**DEFENSE NUCLEAR FACILITIES
SAFETY BOARD**

August 26, 2010

Staff Issue Report

SUBJECT: Technical Basis for Estimating Deposition Velocities,
Hanford Site

Figure 1. Selected deposition velocity curves from Sehmel and Hodgson (1976, 1978).

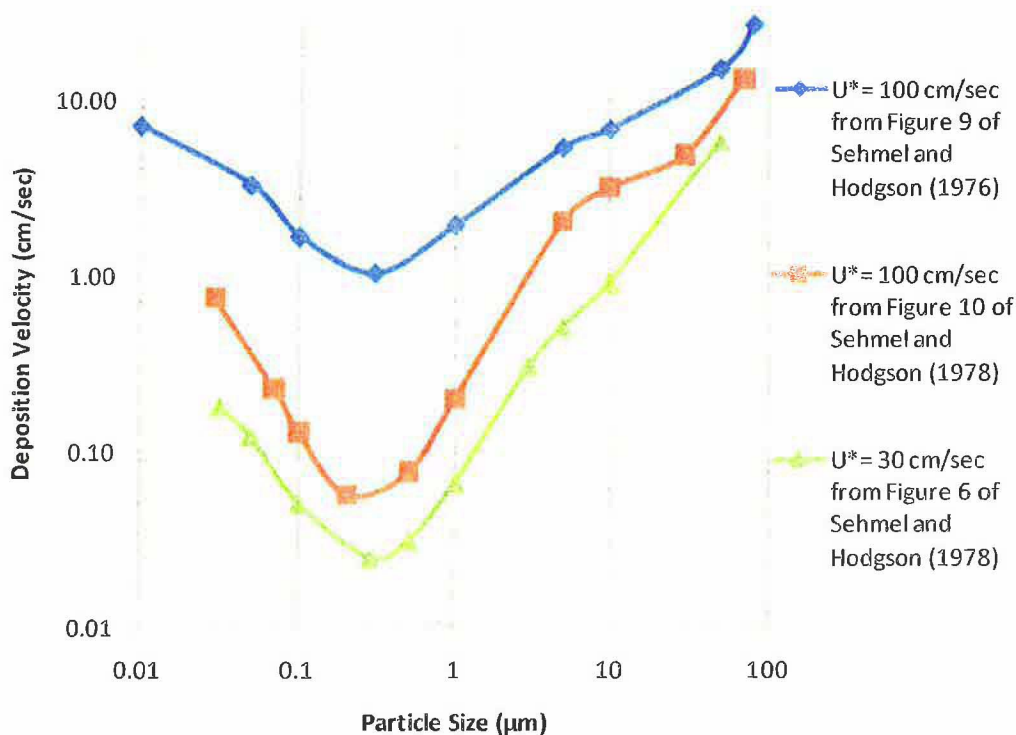
In a letter to you dated May 21, 2010, the Board questioned the technical justification for using a dry deposition velocity of 1 cm/sec. The Board noted that its staff had reviewed published data and believed that a value between 0 cm/sec and 0.3 cm/sec could be technically justified as a dry deposition velocity for aerosols at the Hanford Site. Before DOE revised the safety strategy, the transport analysis for WTP was based on conservative applications of dispersion models and used a dry deposition velocity of 0 cm/sec in the dose consequence analysis. The Board has continued its study of dry deposition velocity and believes the values reported above are technically defensible. The Board also believes that a conservative dose consequence analysis can be obtained by using a single value for dry

deposition velocity by selecting the bounding value within the range between zero and the predicted deposition velocity for the median particle-size. The resulting single value for WTP would equate to a deposition velocity of 0.1 cm/sec for Hanford high-level waste. Details of the analyses performed by the Board's staff are contained in the enclosed report.

DOE established its default dry deposition velocity, 1 cm/sec, based on the work of Sehmel and Hodgson (1976).³ The relevant data from this paper are represented by the blue diamond symbols in Figure 1. This curve corresponds to a surface roughness of 3 cm and a friction velocity, U^* , of 100 cm/sec. As seen in Figure 1, if the 1976 curve is used, selection of a dry deposition velocity of 1 cm/sec would be a bounding value. Sehmel and Hodgson revised

their 1976 model with additional empirical data in 1978.⁴ Figure 1 also shows curves from Figures 6 and 10 of Sehmel and Hodgson (1978) corresponding to friction velocities, U^* , of 100 cm/sec (red squares) and 30 cm/sec (green triangles), respectively. The actual figures from Sehmel and Hodgson (1976 and 1978) are reproduced in Appendix A.

Nonetheless, referring to Figure 1, the green triangle curve (wind speed of 10 mi/hr) shows that 0.03 cm/sec would be a lower-bound deposition velocity. Using the characteristic particle-sizes for the coarse and fine fractions of the two-bin particle-size case (about 3 μm and

0.3 μm , respectively), one could reasonably select a deposition velocity of 0.03 cm/sec for fine particle fractions and 0.3 cm/sec for coarse particle fractions.

Figure 3. Comparison of CARB 3 deposition velocity calculations and NRC expert elicitation data corresponding to median quantiles at a wind speed of 4.5 mi/hr and surface roughness of 5 cm.

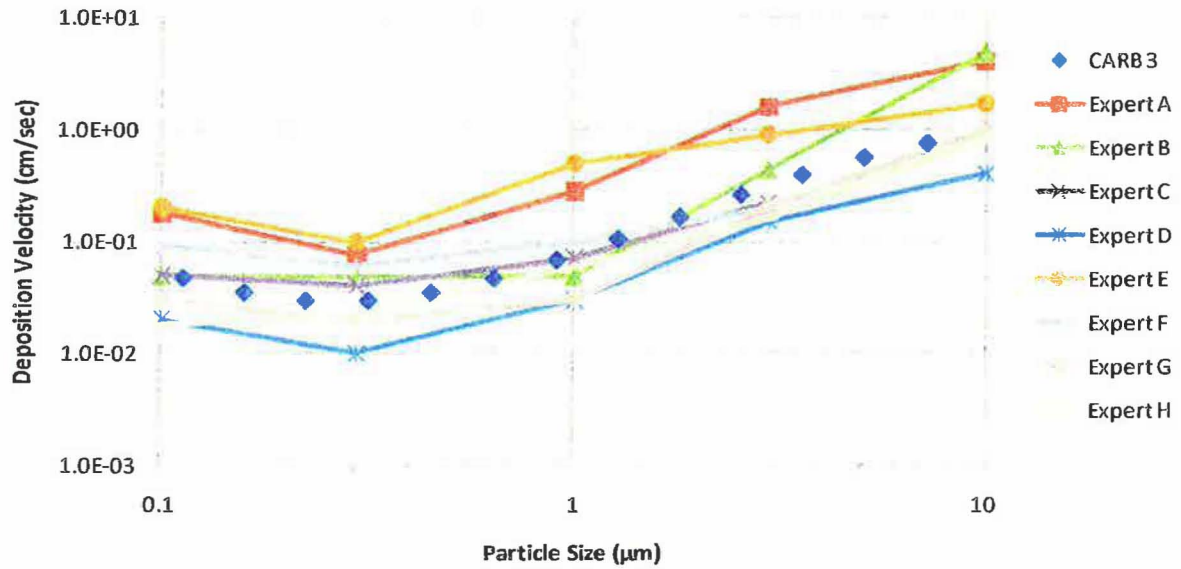
The results show that the CARB 3 model produces results that are within the range of median values from the NRC expert elicitation and above (less conservative than) the lower 5th percent quantile data. This indicates that the CARB 3 model is more representative of median than of the lower 5th percent quantile values for deposition velocity. If we were to use solely the expert elicitation data as presented, the deposition velocity selected for the Hanford Site would be lower than ultimately believed to be a reasonably bounding value. The NRC constrained this expert elicitation to spherical particles with a specific gravity of unity (density = 1g/cm³). For this reason, direct use of the NRC expert elicitation data is limited to low-density particulate releases. Because of this limitation, we do not believe it is appropriate to use the lower 5th percent quantile data from NRC as a reasonably conservative input value. The data do support that the dry deposition velocity predicted by CARB 3 should not be exceeded when one is determining a reasonably conservative value. Accordingly, we will rely on the calculations from the CARB 3 model even though it appears to be more representative of median values of dry deposition velocity based on the expert elicitation data. If NRC releases an updated correlation
